SYDNEY EASTERN CITY PLANNING PANEL SUPPLEMENTARY REPORT

RESPONSE TO THE PANEL'S DEFERRAL

- c) THAT Development Application No. 2019/359 for retention of part of Church Street facade, demolition of all remaining structures, excavation for basement parking levels and construction of two (2) x thirteen (13) storey mixed use buildings comprising ground

Figure 2: Existing landscaping adjacent to the brick facade

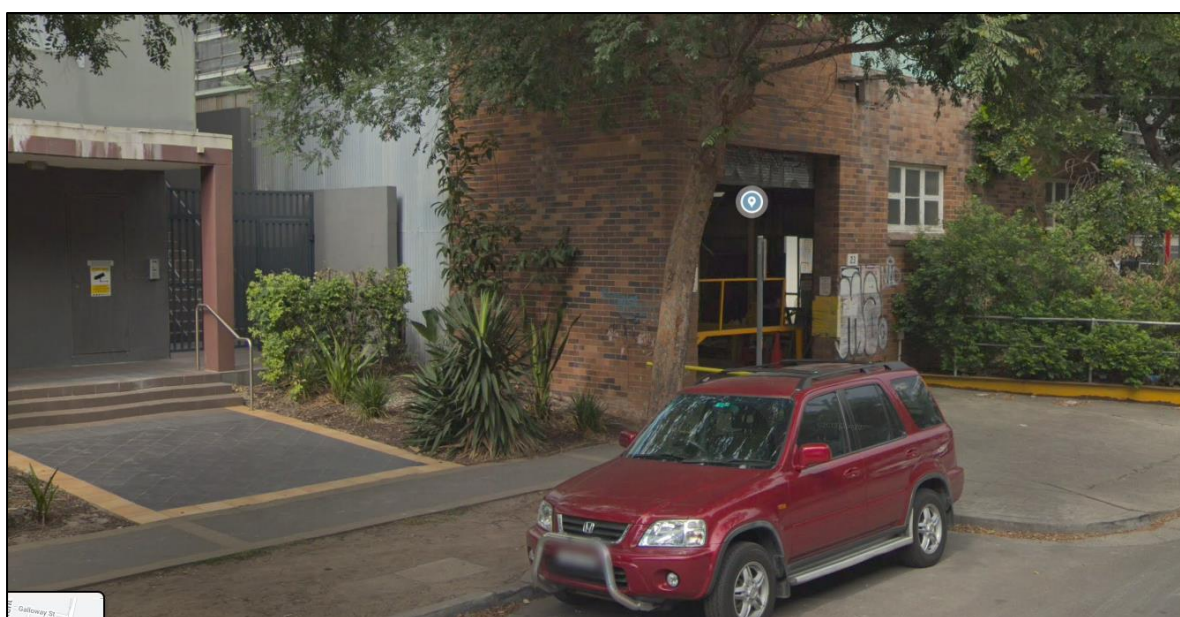
The existing landscaping at the front of the neighbouring building to the east that is not shown in the amended material. This would inhibit the ability to walk directly through the retained portion of the building which sits within the land dedication area identified, unless the landscaping is removed. What is also evident from the diagram above is that the portions of existing fabric retained are within the identified public domain area. Council maintains its position expressed in the original assessment report (included as attachment) on this issue and does not support the structures retention. It is also noted that details would be required (i.e. – construction methodology/structural engineer review) to demonstrate how the retained portions of building would occur in light of the basement excavation works plus any necessary site remediation works.
